1 **ADDENDUM NO. 5**

2 **ISSUE DATE: June 18, 2018**

3
4 **RE: GOODMAN SOFTBALL LOCKER ROOM REMODEL**
5 **UNIVERSITY OF WISCONSIN, MADISON - ATHLETICS DEPARTMENT**
6 **MADISON, WISCONSIN**
7 **UW-Madison Project No. MSN-0175-1701 / UWSA Project No. A-17-008**
8

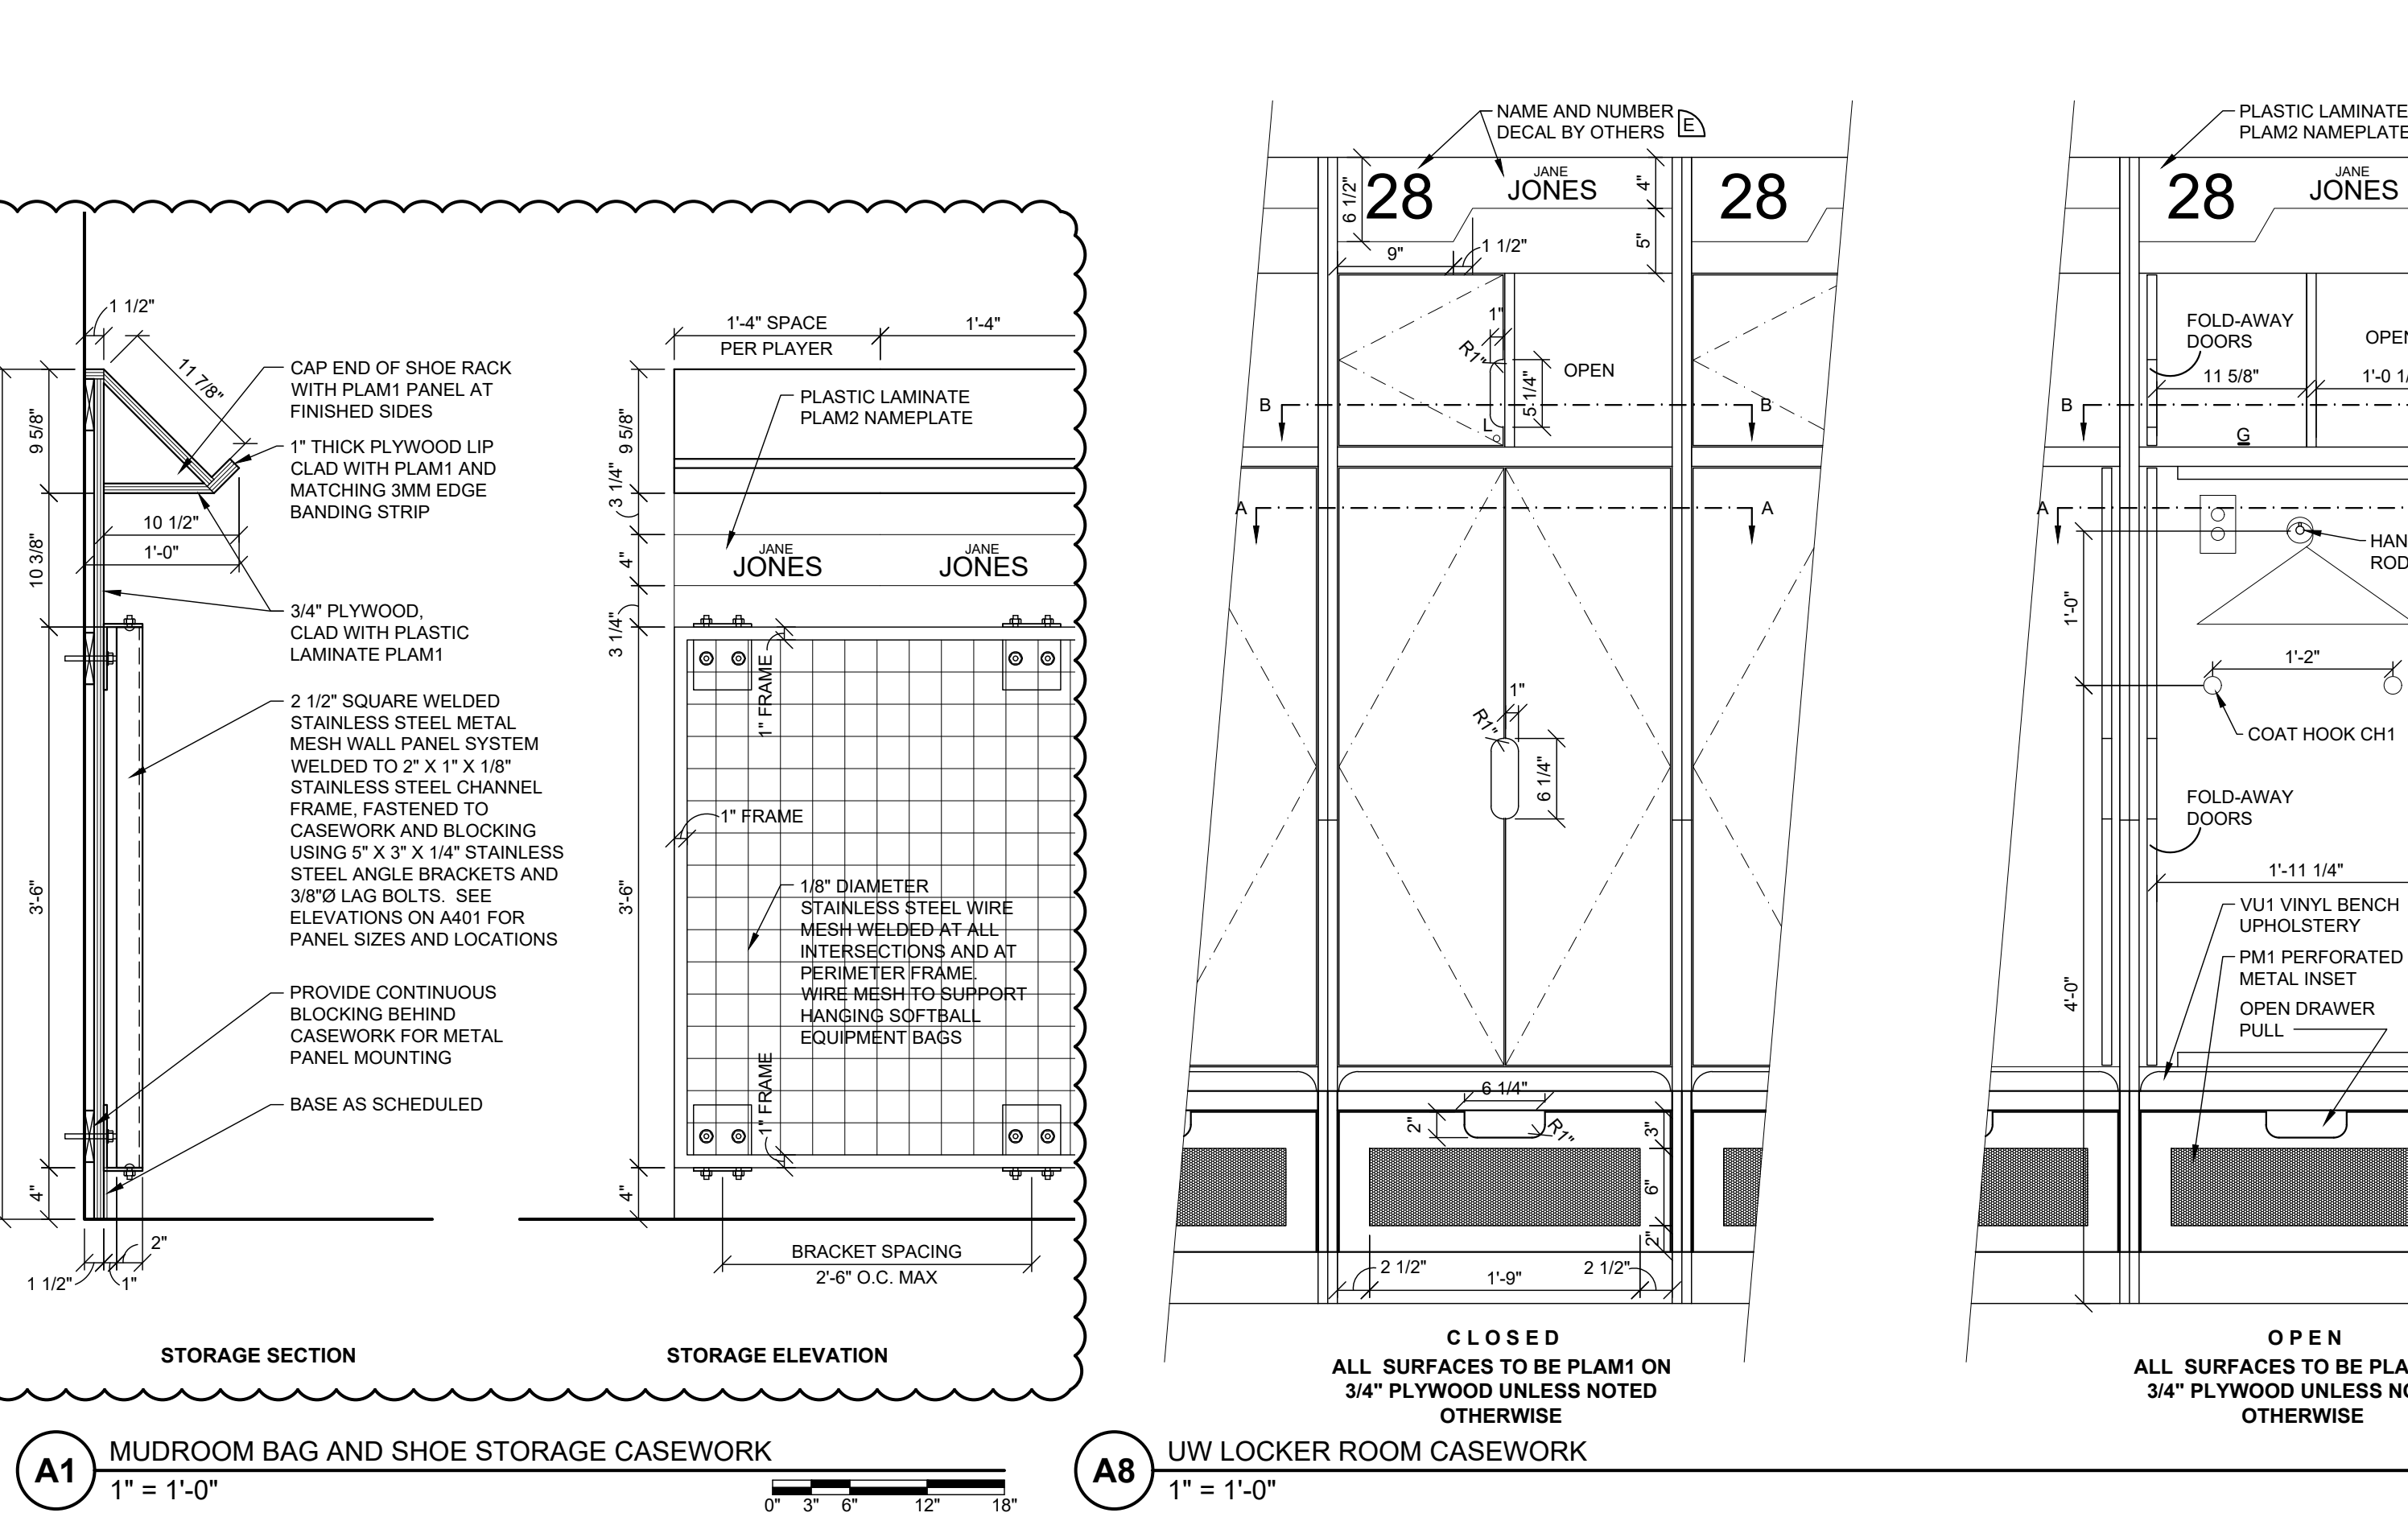
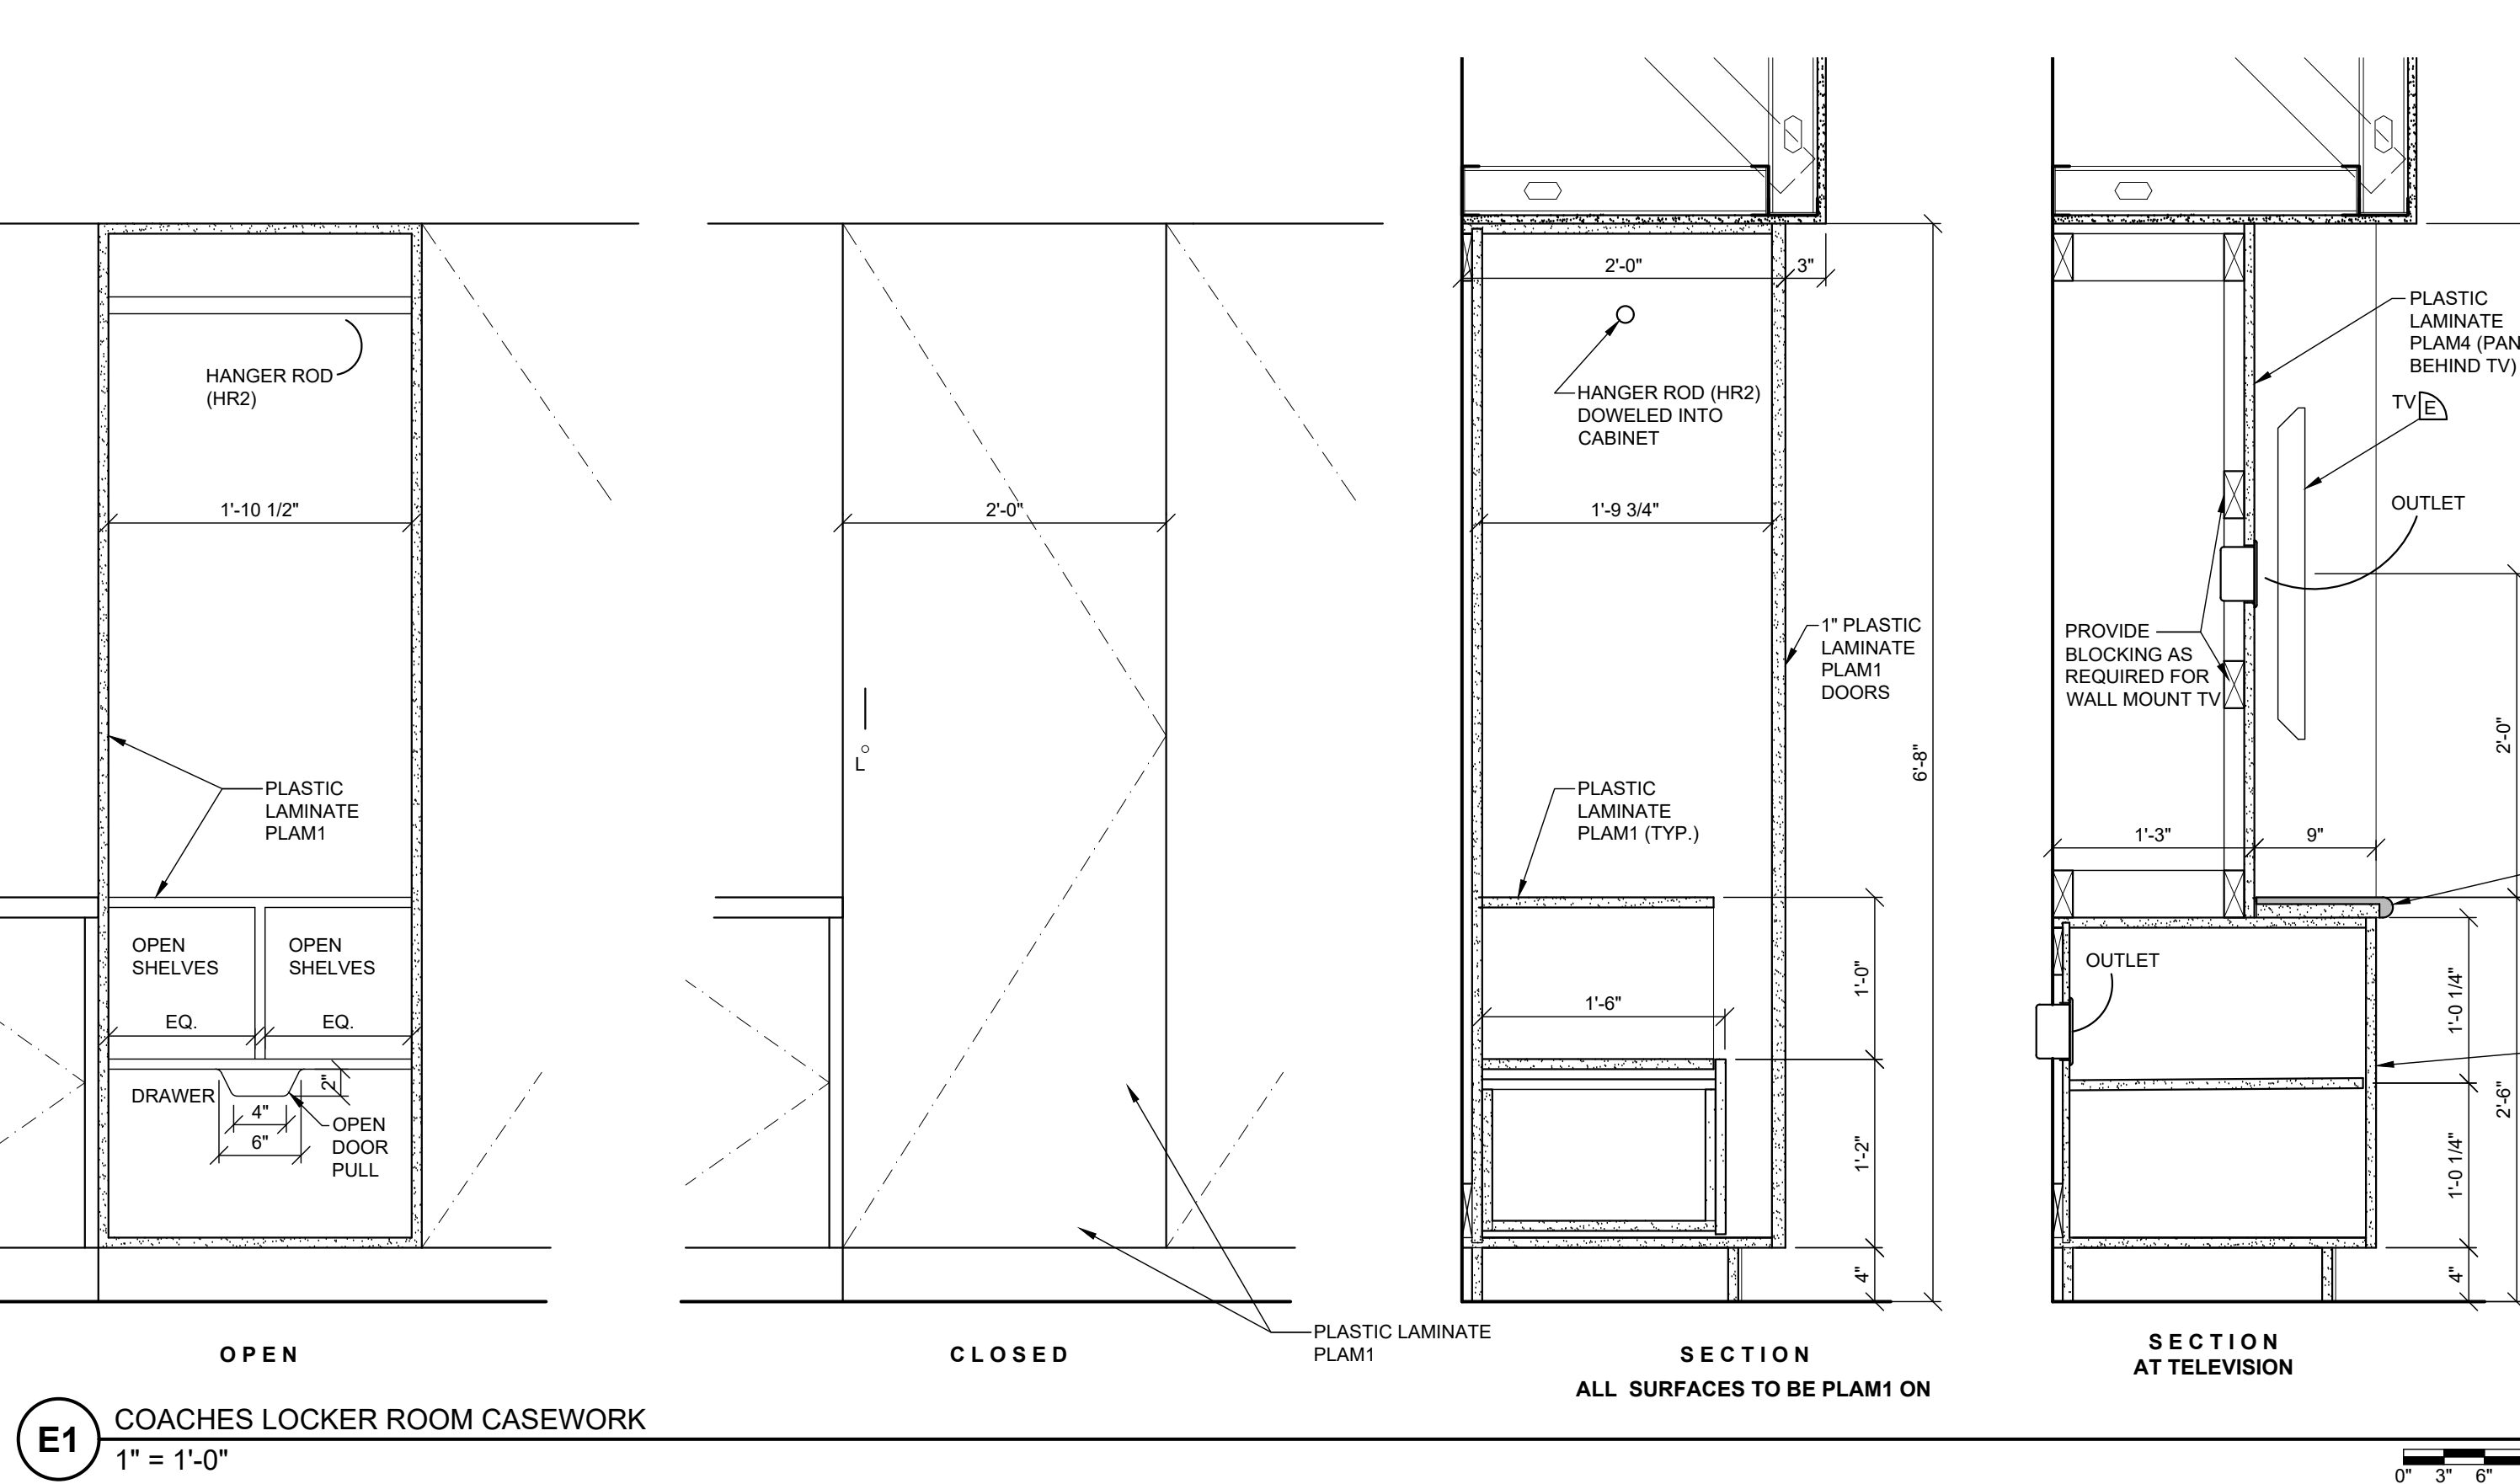
30 6. QUESTION: Sheet A401, details E6, E8, E10 show a Metal Mesh Panel System in the Mudroom.
31 Detail A1/A701 gives some specifications for how these are constructed, although there doesn't appear to
32 be anything in the specifications. Plan E13/A401 - Enlarged Basement Floor Locker Room shows the
33 Mudroom Metal Mesh System as being existing. Please clarify.
34

A. Page 05 50 00-1, line 11, add: "Furnish and install metal mesh panel system."

Fabricate panels and mounting brackets as noted on drawings. All fasteners shall be stainless steel.

Mounting hardware shall be securely anchored through wood blocking located behind the plastic laminate back panel.

35 RESPONSE: Metal mesh panel system in mudroom is new and to be provided by General Contractor in their
36 bids. Existing/Owner-furnished symbols on plan detail E13/A401 are in reference to the seating stools
37 in the center of the room, not the metal mesh panel system.
38
